CITY OF WOODBURN
COMMUNITY DEVELOPMENT

MEMORANDUM

Date: June 8, 2020
To: Dago Garcia, P.E., City Engineer
Cc: Chris Kerr, AICP, Community Development Director
Roy Hankins, PE, Emerio Design
From: Colin Cortes, AICP, CNU-A, Senior Planner *cc*
Subject: **Planning Division review comments on original / 1st submittal of civil engineering plans for Smith Creek Development Phase 3B**

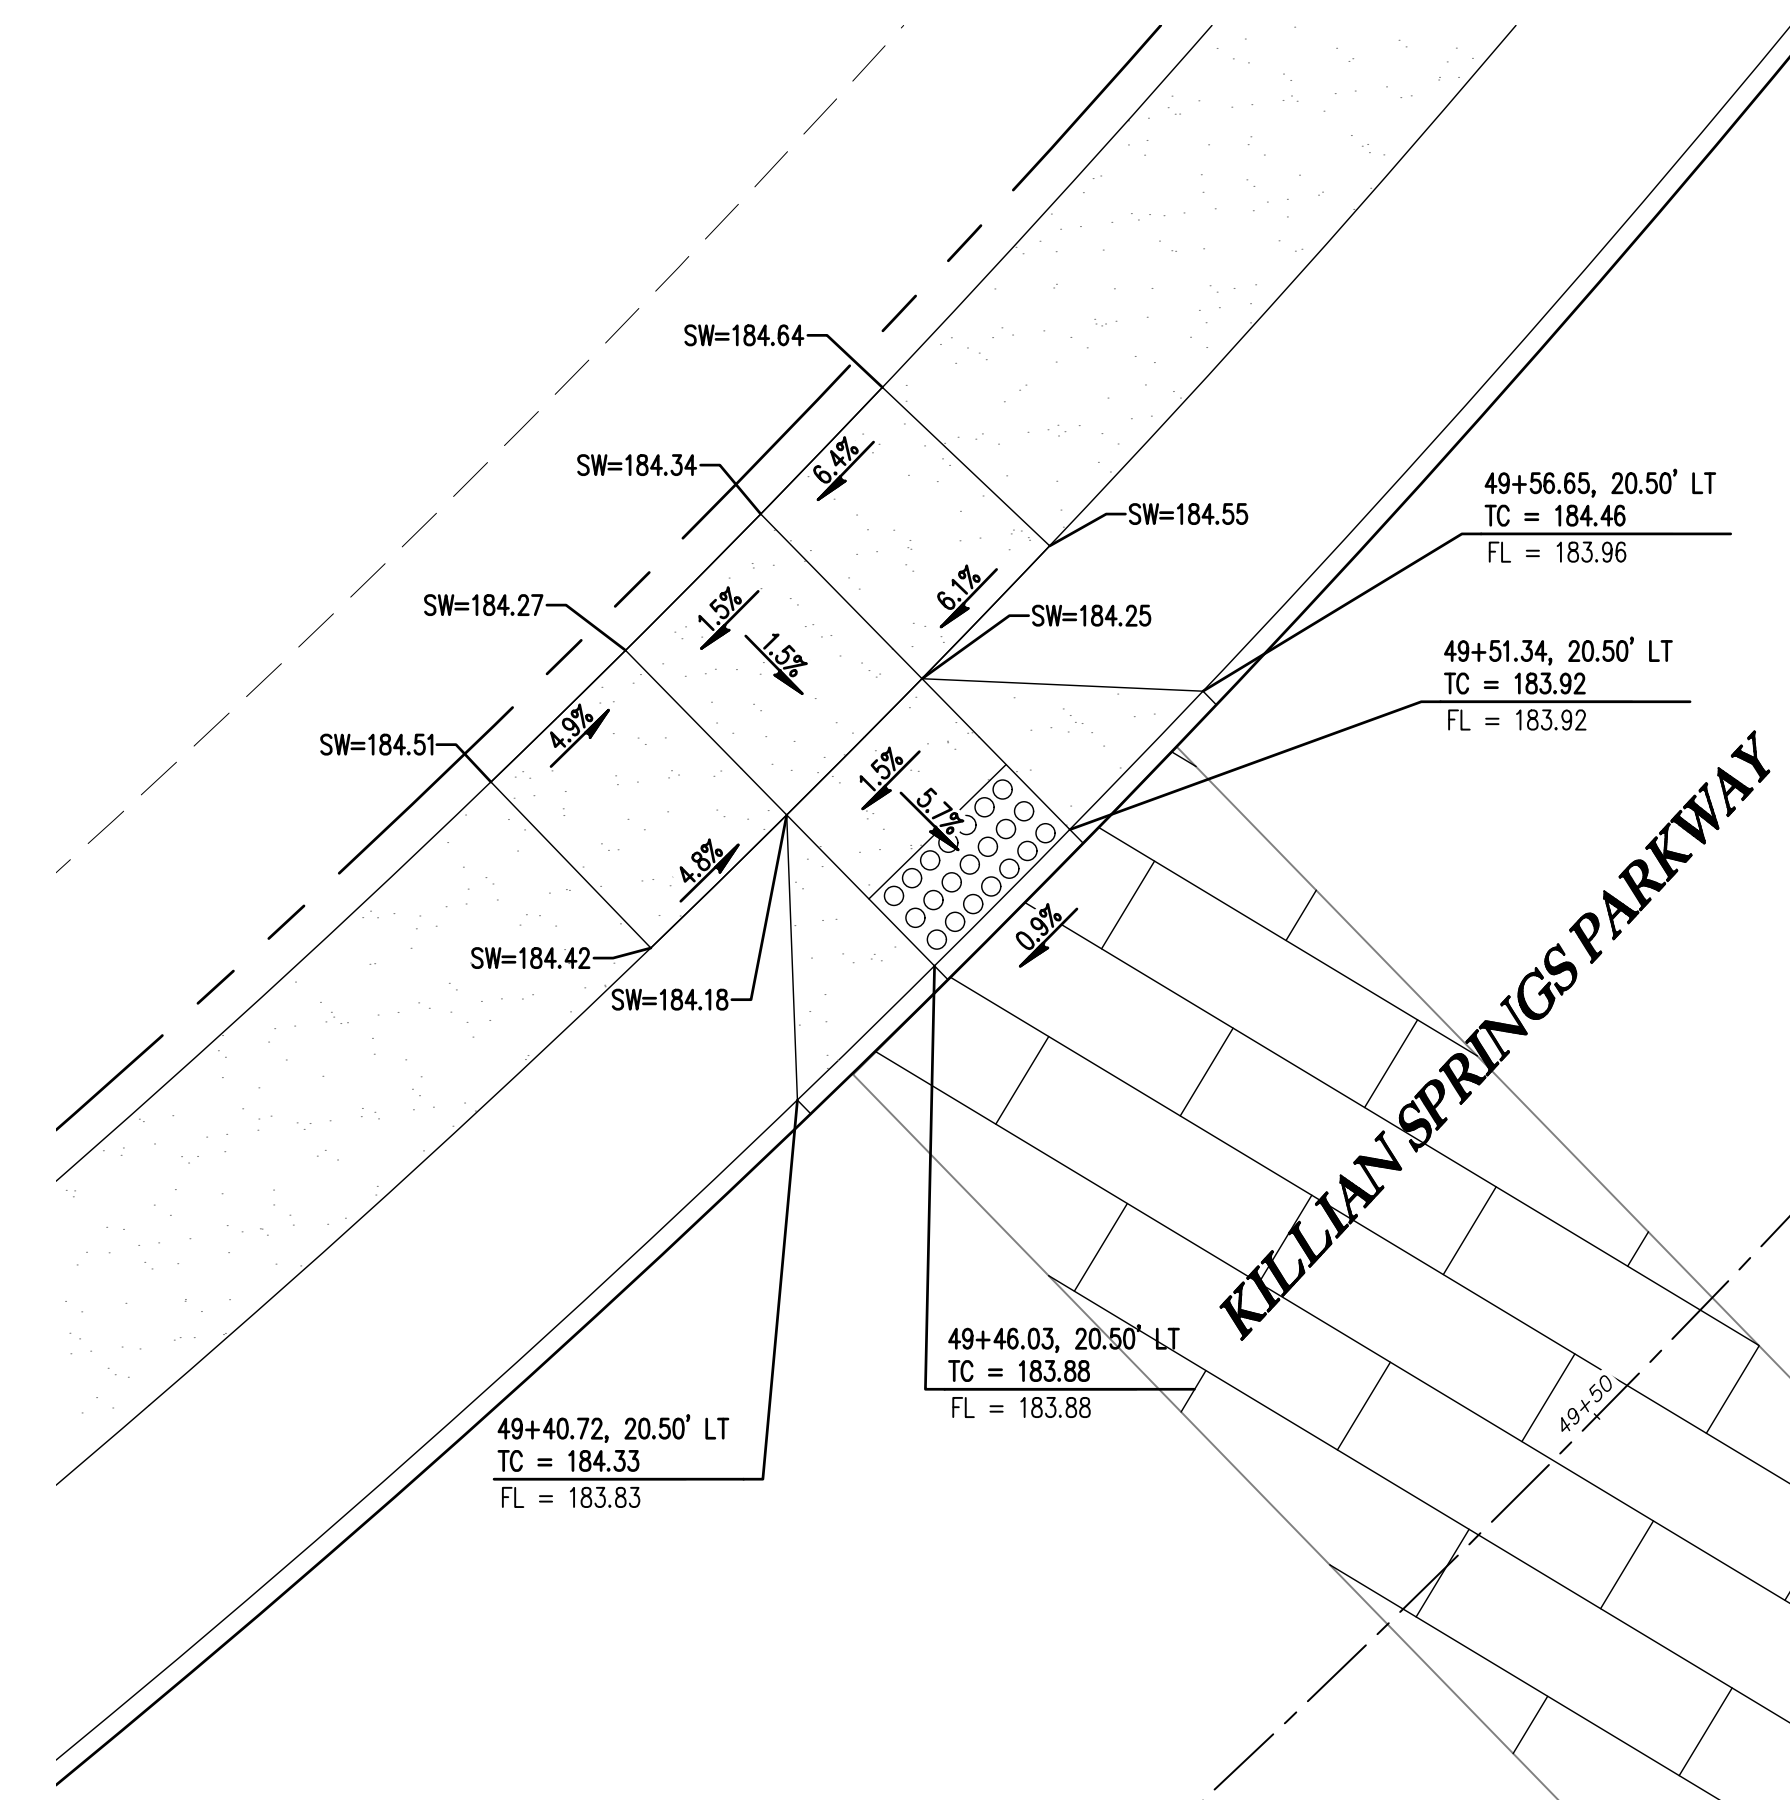
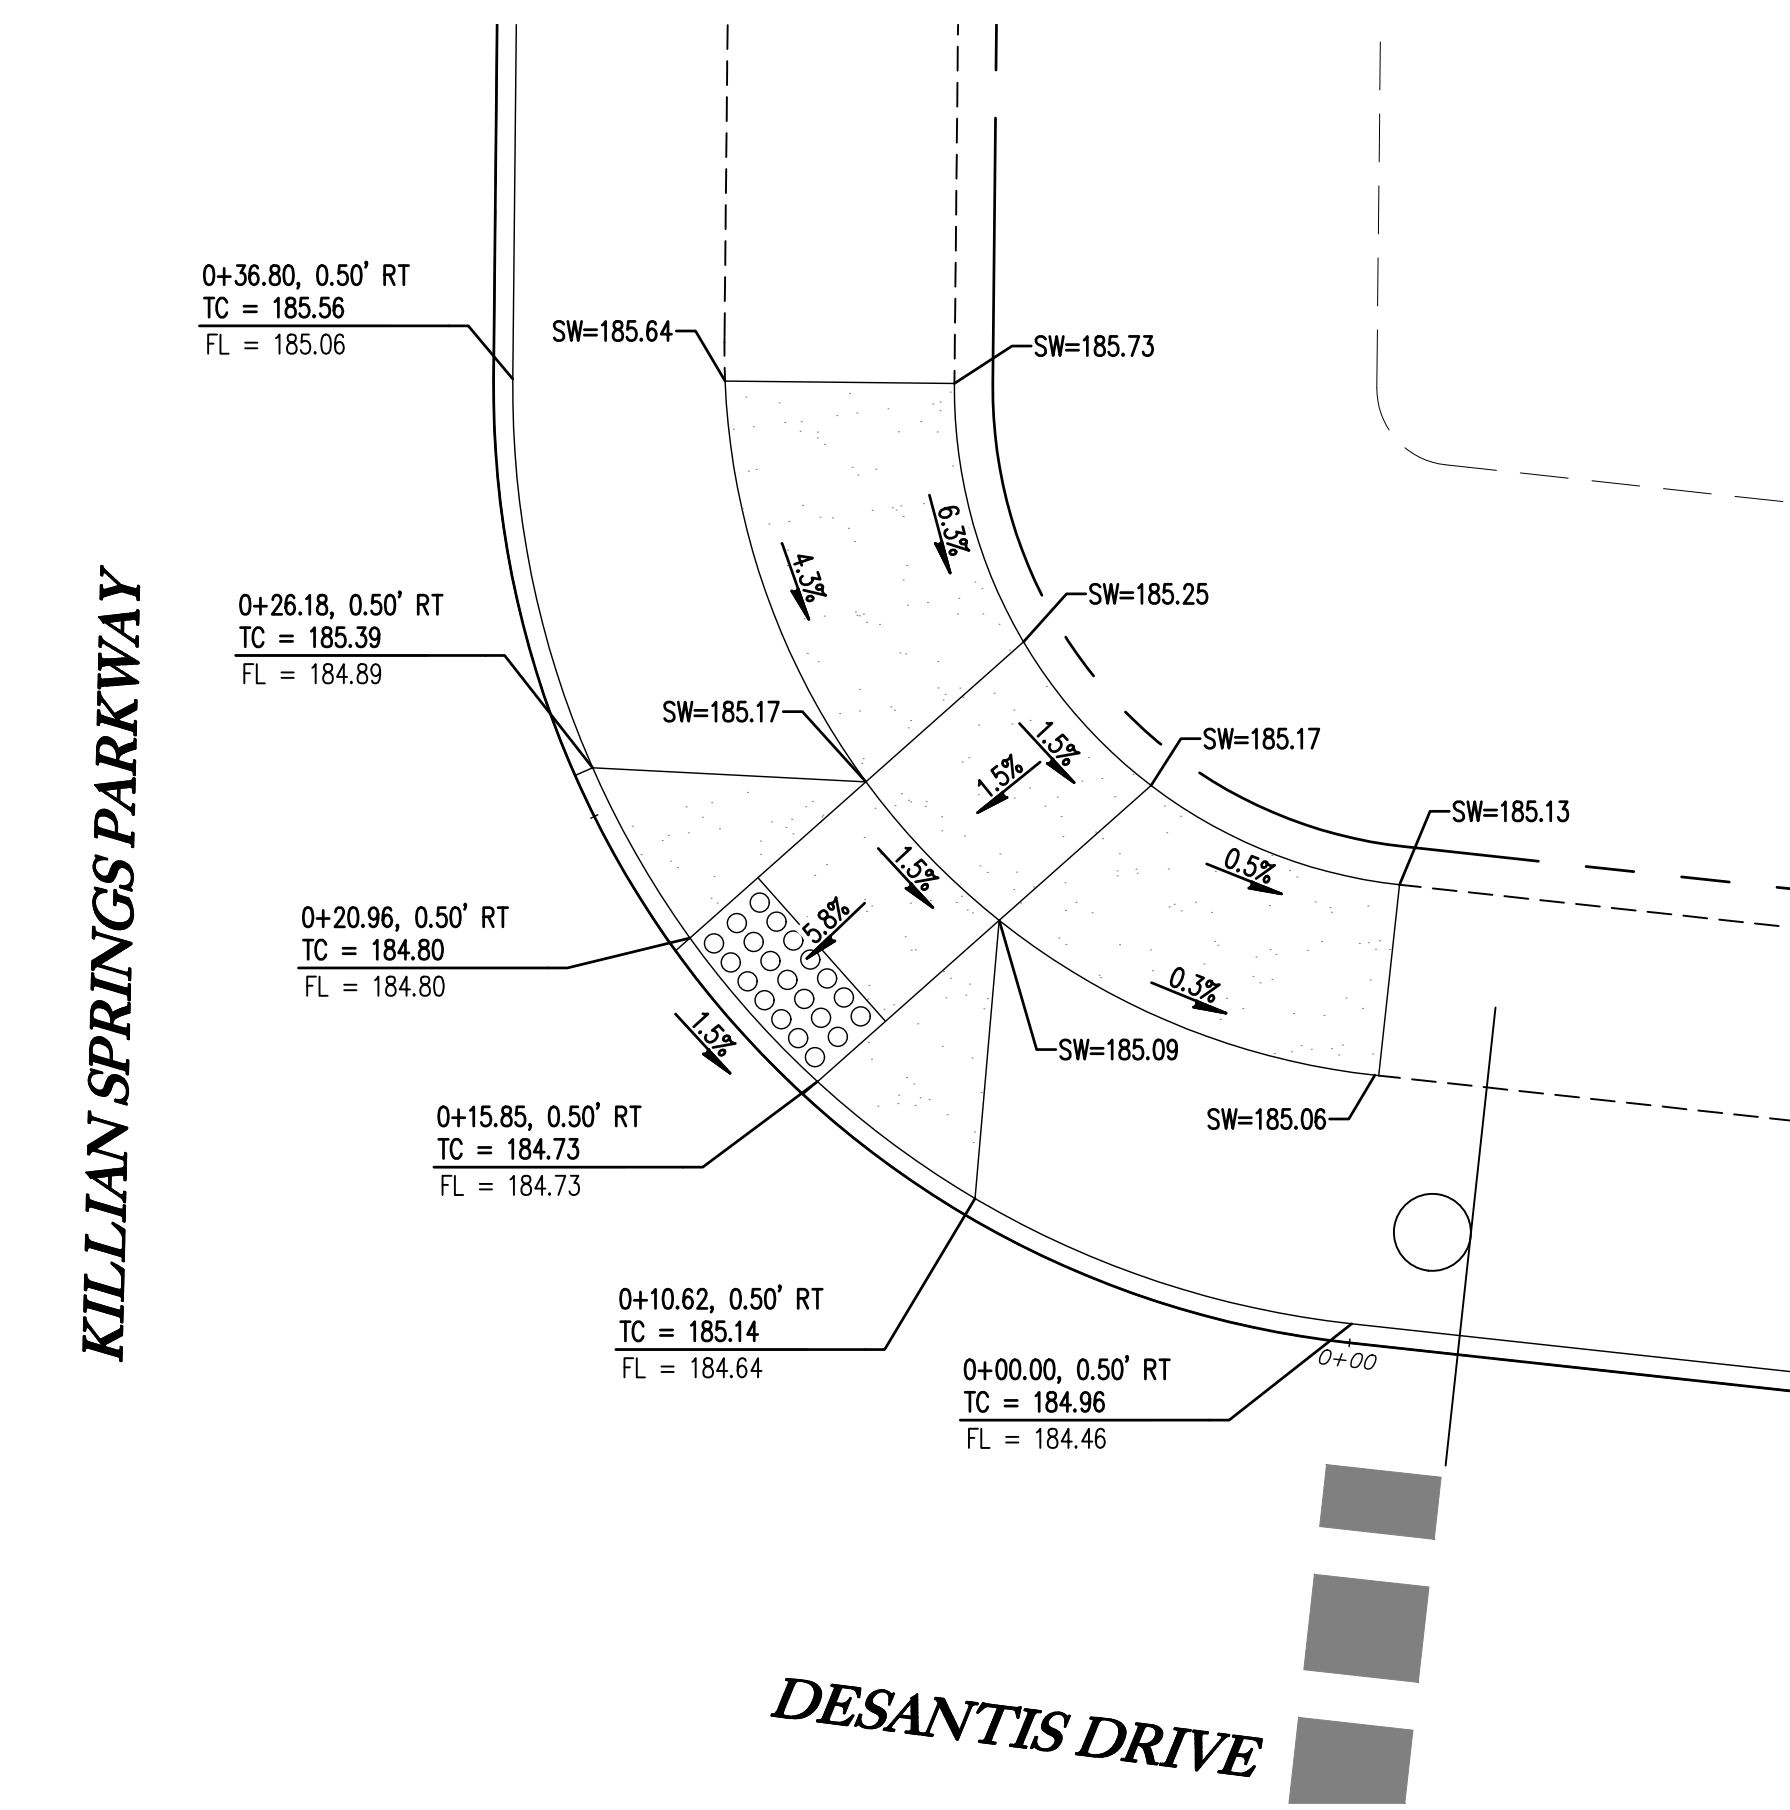
- A. Crosswalk treatments:
 - Sheet 3: Stamped concrete crosswalks typical section; and
 - Sheet 16: Curb return details 7, 9, 10, & 12:

The information is too vague to indicate pavement stamping/treatment, color, and pattern in conformance to the attached excerpted memo I'd sent Stafford Land Co. in August 2019 in response to a request to staff to direct on these topics when the issue first arose for Smith Creek through Phase 1A civil engineering plans.

Revise at least Sheet 3 to indicate conformance with the memo by providing any of notes, diagrams, and images. The excerpted memo is Attachment 1.
